CCK-2564.0-16-25 HEB BP-05 Interiors

ADDENDUM #2

UK Construct Health Education Building
ADDENDUM No. 2
UK-2564.0-16-25
01/13/2025

1 IT PLAN - FIRST FLOOR - AREA B
1/8" = 1'-0"

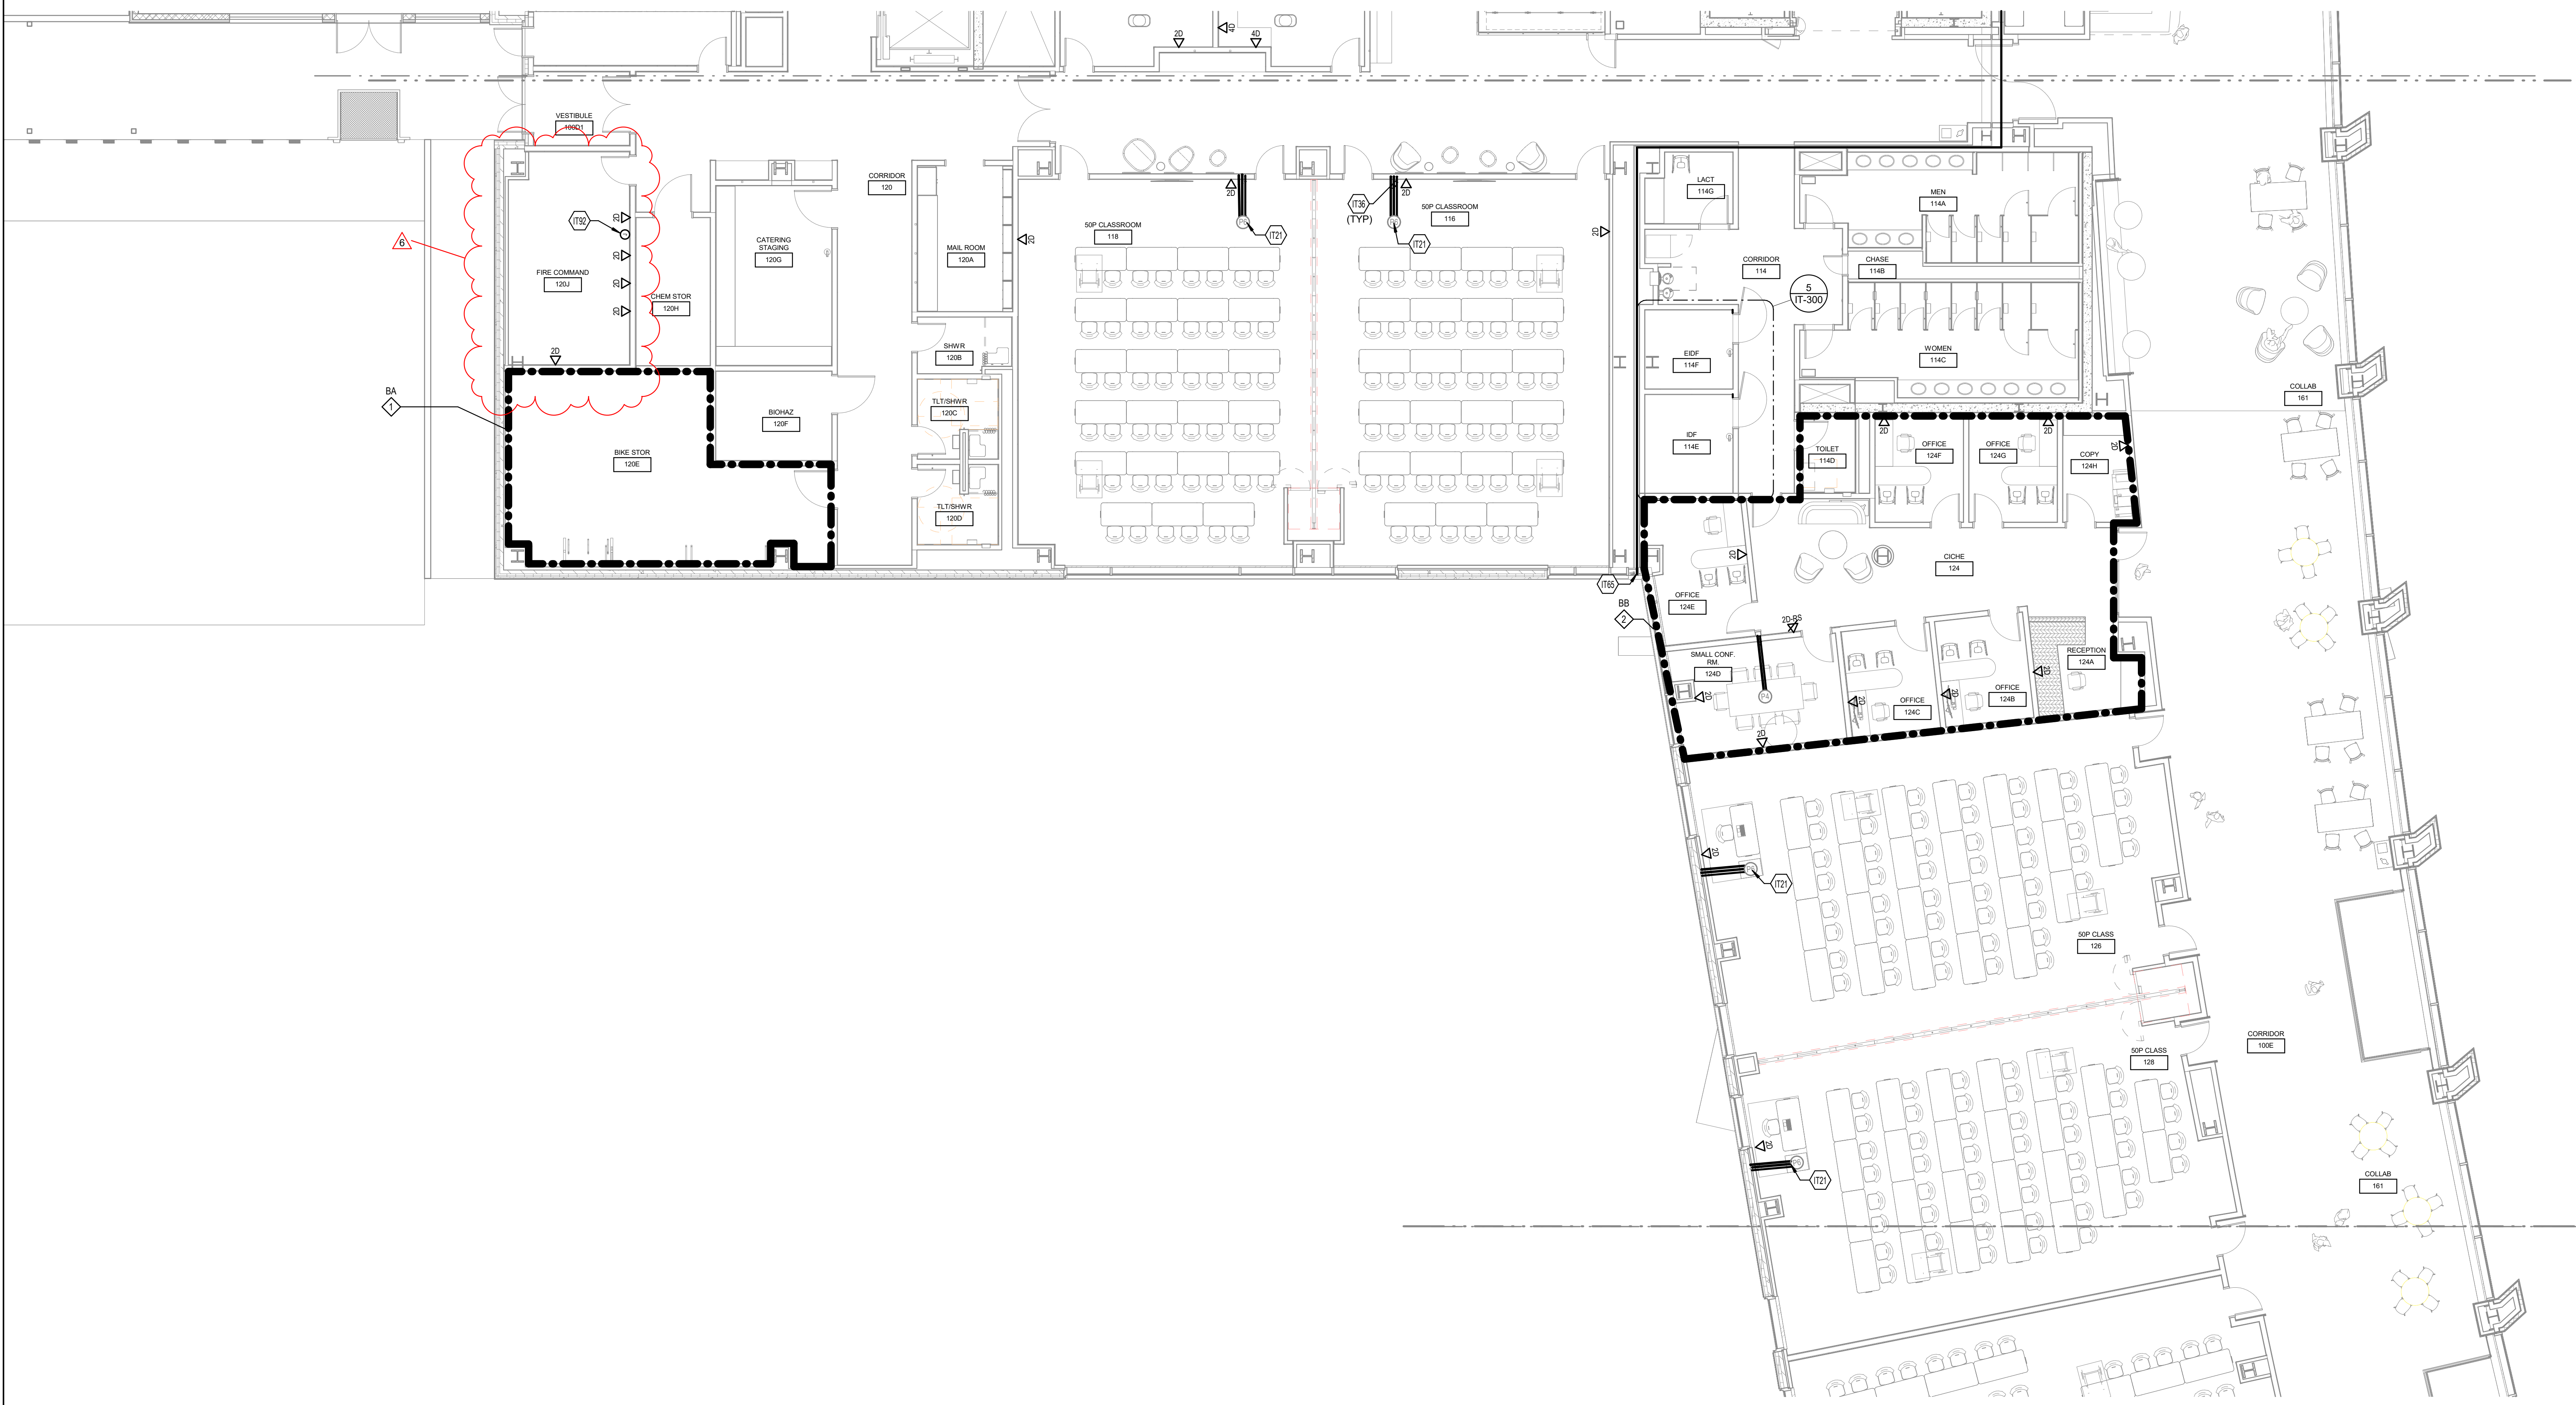
Refer to drawing IT-101B – IT PLAN – FIRST FLOOR – AREA B

- A. Data outlet has been added for the generator annunciator panel and additional fire protection equipment in Fire Command Room 120J.

1 IT REFLECTED CEILING PLAN - NINTH FLOOR - AREA B
1/8" = 1'-0"

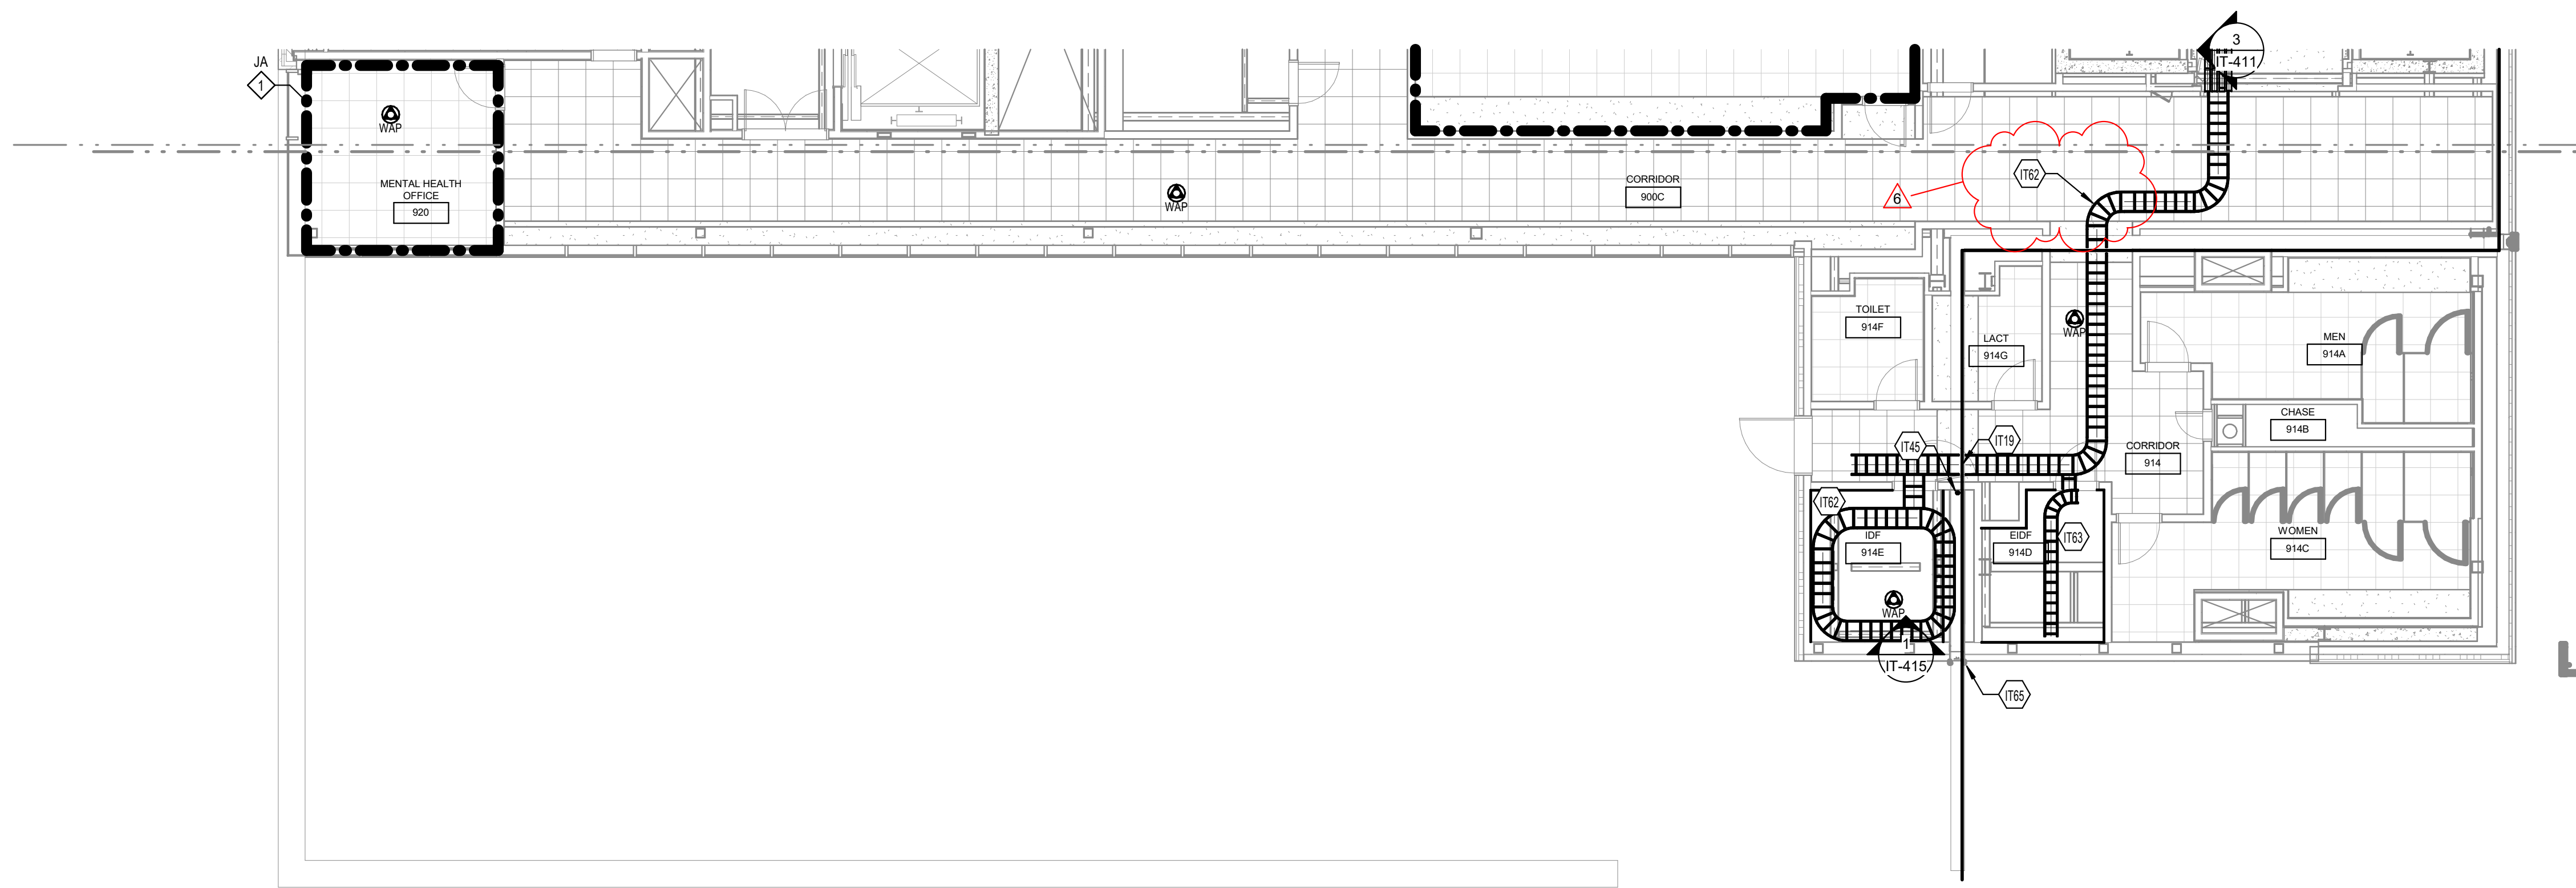
Refer to drawing IT-209B – IT REFLECTED CEILING PLAN – NINTH FLOOR FLOOR – AREA B

- A. Add tagged note IT62 to indicate corridor cable tray is to be 18" wide.
